City of Campbell River Report/ Recommendation to Council

Subject: Upland Excavating Ltd. Proposed Landfill, Draft Operational Certificate City Peer Review

RE: Hydrogeological Review of the Proposed Upland Landfill

Figure 2: Sand and Gravel Aquifer Groundwater Elevation Contours, developed from April 6, 2017 groundwater elevation data (GHD 2017b)

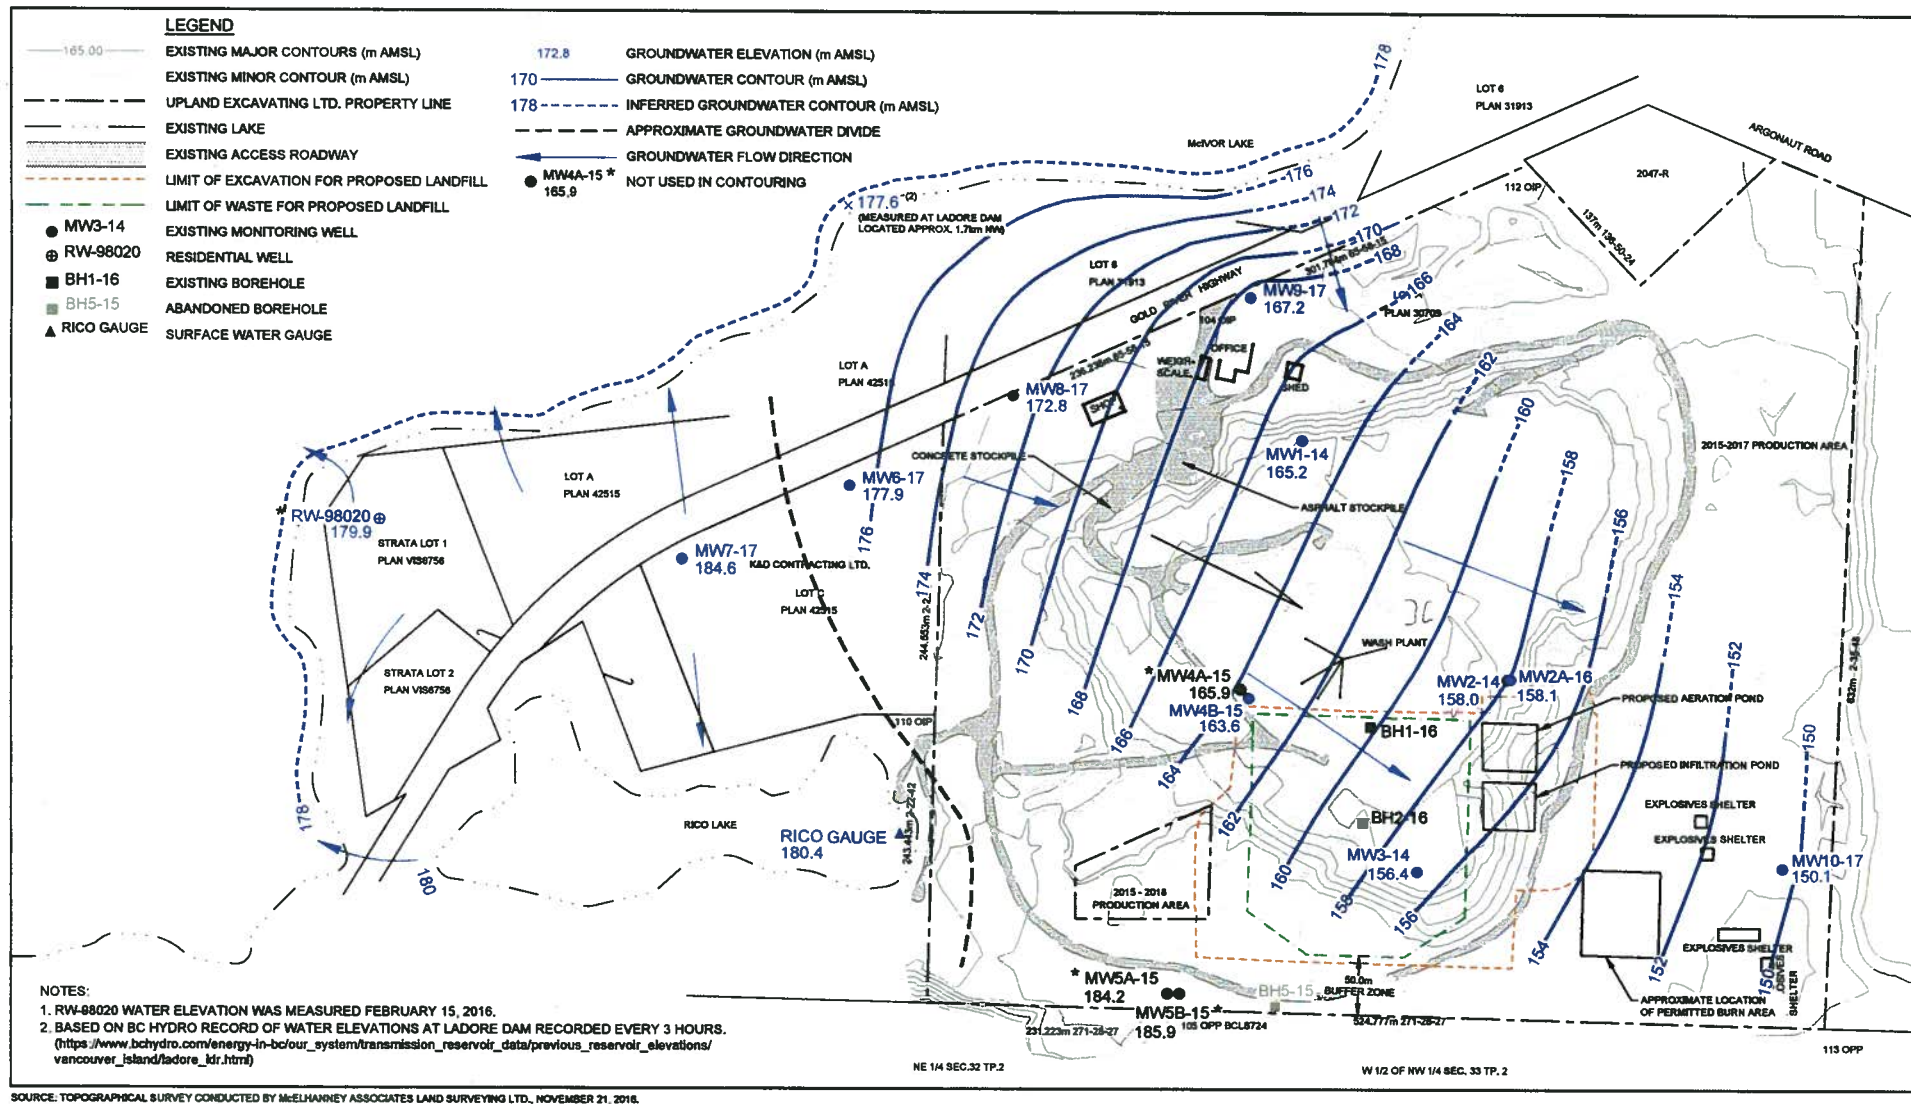
The limited groundwater level data set collected for the Site indicate that groundwater is flowing from the lakes across the Upland gravel pit property to the southeast, shown on Figure 2. For the gradients to reverse, causing groundwater to flow from the landfill area to the lakes, the hydraulic head in the landfill, infiltration ponds and/or pit area would have to be higher than the water levels in the lakes. Furthermore, for contamination from the landfill to reach the lakes the gradient reversal would have to be maintained for long enough for contaminants to migrate to the lakes. It should also be noted that even if water levels in the pit area build up to a level higher than the lake levels there will likely still be a significant hydraulic gradient moving groundwater primarily to the southeast.

(Waterline annotations in red)

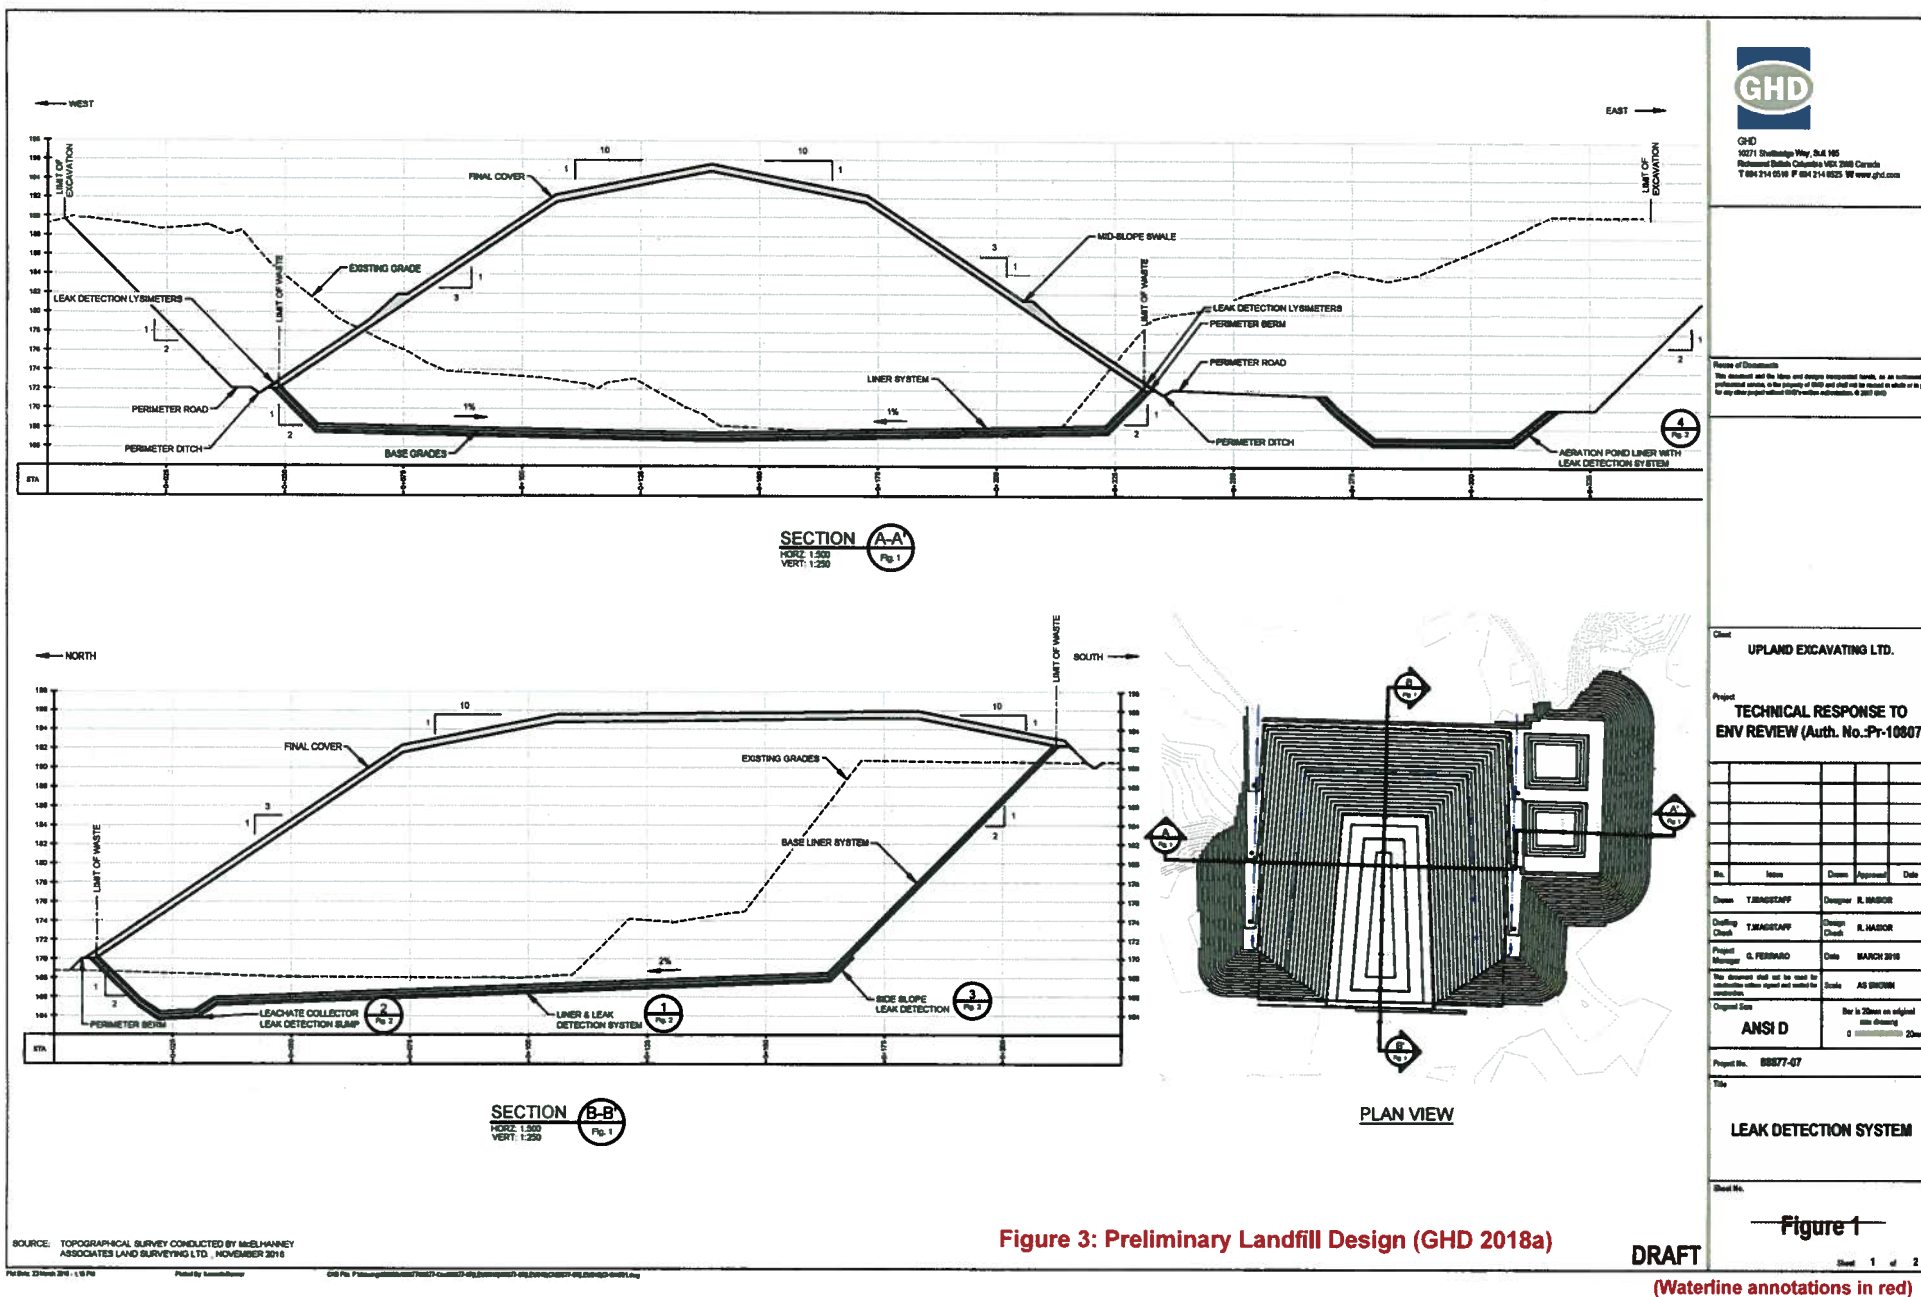
The landfill design presented by GHD (2018a) is reproduced as Figure 3 for reference purposes. It shows the base of the landfill sloping from an elevation of 168 m AMSL on the south side to a sump elevation of 164 m AMSL at the center of the northern edge of the landfill. As referenced in GHD's DOCP report, the Landfill Criteria for Municipal Solid Waste (ENV 2016) requires that the landfill base be maintained at a minimum height of 1.5 m above the groundwater table at all times. Insufficient water level data has been collected to demonstrate that groundwater levels will remain 1.5 m below the base of landfill. In fact, groundwater levels at MW4A-15 was measured at 165.9 m AMSL on the 6 April 2017, and at 165.2 m AMSL in MW4B-15 on the 11 September 2015 which are above the design elevation of the sump and likely do not meet the ENV landfill criteria. It should be specifically noted that no groundwater level measurements have been collected in the months of November or December which are generally the two wettest months of the year in the Campbell River area based on the historical precipitation record (Government of Canada 2018).

Figure 4: Updated Bedrock Contours (GHD 2018d)

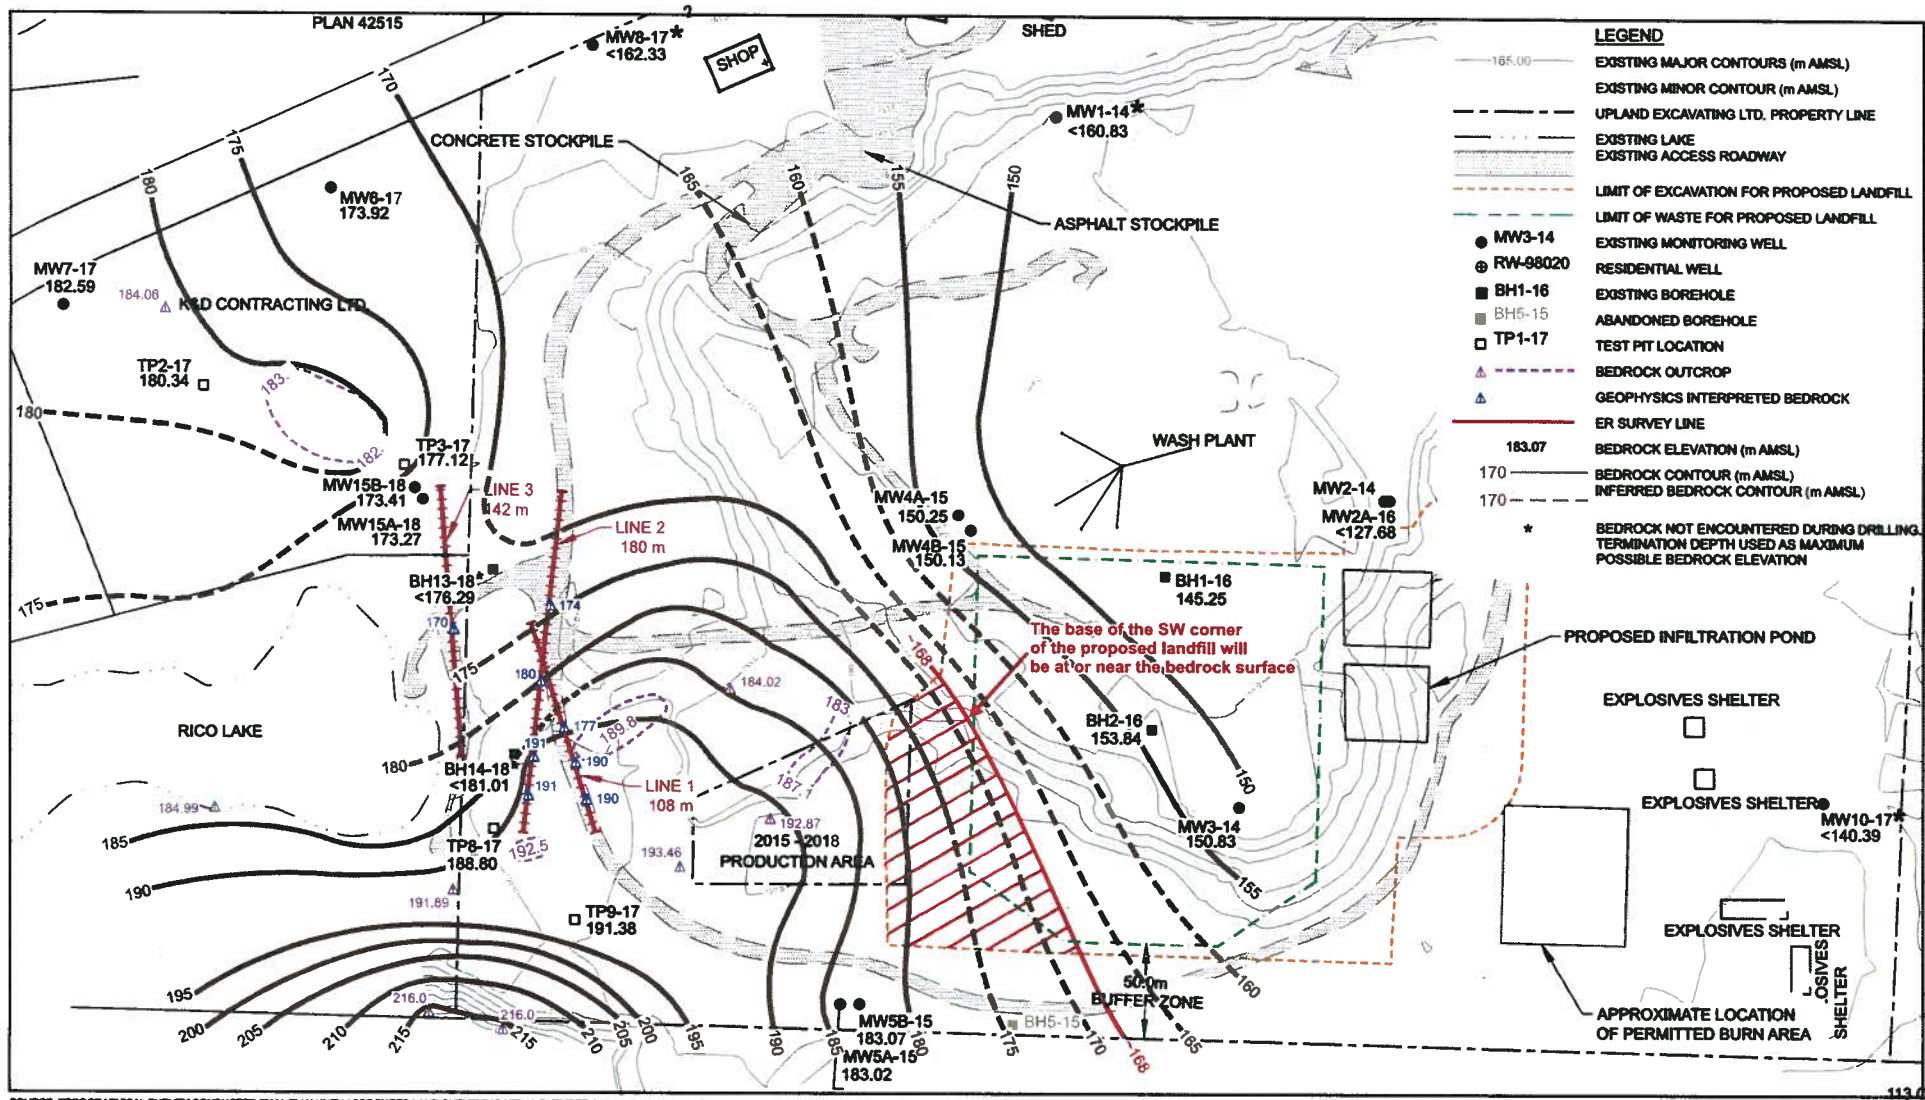
- The new bedrock contours developed from the recent geophysical investigation on site imply that the southwestern portion of the landfill will be situated at or near the bedrock surface. Groundwater level data collected from monitoring wells completed in bedrock show groundwater level elevations measured above the top of the bedrock and above groundwater levels measured in the sand and gravel aquifer. The bedrock groundwater level data do not appear to have been considered in relation to the Landfill Criteria described above.

The bedrock at the site is described by GHD (2107b) as a Karmutsen Formation basalt with a varying degree of weathering and fracturing. The hydrogeological characterization of the bedrock beneath the Site has been largely focused on assessing the potential hydraulic connection between the proposed landfill and Rico Lake. An annotated copy of the GHD's bedrock surface contour map is included as Figure 4 (GHD 2018d). The updated bedrock contours (Figure 4), show that the southwest corner of the proposed landfill will be at or near the bedrock surface. Groundwater level data collected by GHD from monitoring wells completed in bedrock show groundwater level elevations consistently being measured above the top of the bedrock and above groundwater levels measured in the sand and gravel aquifer (Figure 5). This information indicates the presence of an upward gradient from the bedrock to the sand and gravel aquifer. Considering the updated bedrock surface present by GHD (GHD 2018d) and the observed groundwater levels in the bedrock, the piezometric surface of groundwater in the bedrock would likely be above the base of the landfill in the southwest corner of the proposed landfill. The bedrock groundwater level data do not appear to have been considered by GHD in relation to the ENV landfill criteria requirement of that groundwater levels be maintained 1.5 m below the base of the landfill.
